STS-122 Integrated Delta Launch Site Flow Review

STS-122 Integrated Delta Launch Site Flow Review

Baseline the STS-122 Mission Specific Requirements and Flow Plans.

STS-122 OV-103 Flt 34 – DLSFR Updates

Location of Modified FRSI Plugs

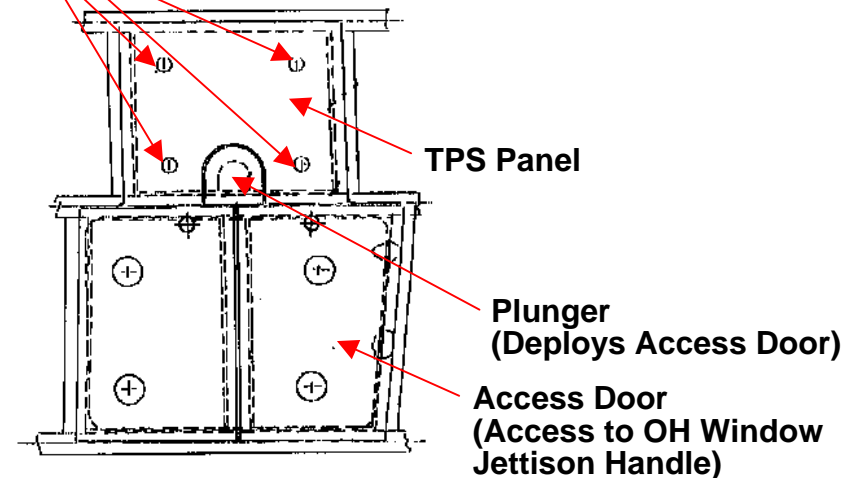
- **30005 Bond FRSI Plugs Into Emergency Egress Access Door TPS Panel**

The four FRSI plugs installed in the TPS panel of the RH forward fuselage emergency egress access door installation are a potential debris source. This mod will apply RTV bond to the FRSI plug installation to reduce the likelihood of dislodging during flight. This change does not affect ground crew rescue procedures.

Note: The changes to the above holes do not affect the ground crew rescue procedures.

- **23488 ECO Sensor Instrumentation (Baselined at STS-122 LSRR)**

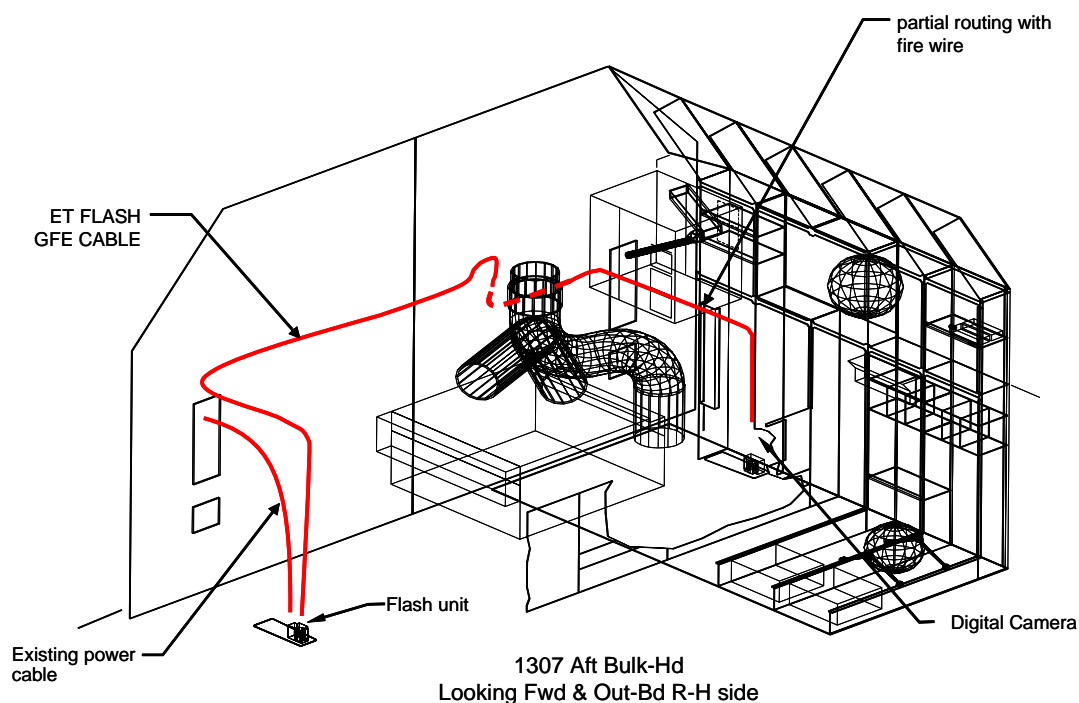
Baselined mod implements voltage measurements for all four MPS ECO LO2 and LH2 Sensor Transducer Circuits to provide insight into ECO sensor system performance anomalies.

Potential design changes are currently being evaluated to address a recently discovered design deficiency. The current design can potentially induce a failure in the MPS Point Sensor Box (resulting in erroneous sensor reading) due to inadvertent short circuit on the ECO Sensor instrumentation return circuit wiring, which is not electrically isolated.

Installation of this mod on OV-103 has not yet begun, and is on hold pending final re-design definition. A decision to implement the re-design for STS-122 (vs. de-baselining) will be made based on engineering and hardware availability to support remaining processing schedule.

Orbiter Umbilical Cameras and Flash Concept

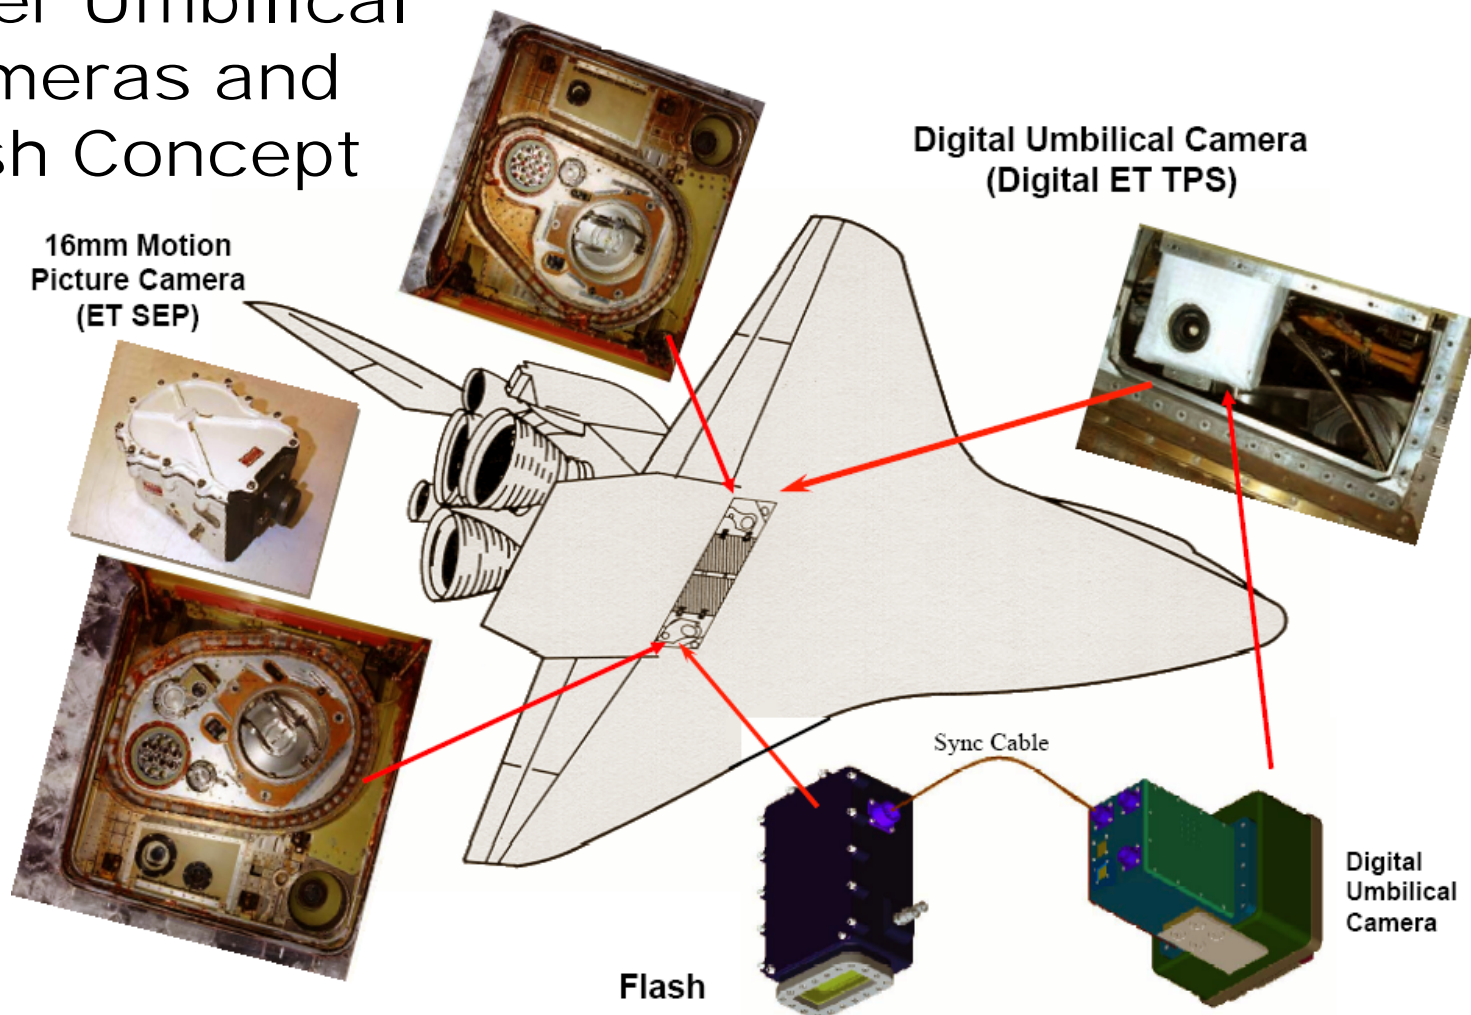
- **30001 ET Umbilical Camera Flash Installation (Wiring Scar Only)**

This modification will install a flash unit in the RH ET Umbilical to be utilized with the ET Umbilical Digital Camera to provide supplemental light to illuminate the external tank (ET) for imagery during separation. Flash will fill in shadow areas during daylight and provide illumination for night launch.

If the GFE cable delivery dates support implementation, GO has the option of installing the GFE cable scar in the aft fuselage during the STS-122 (flight 34) flow (and install the flash unit during flight 35 flow when remaining hardware is available)
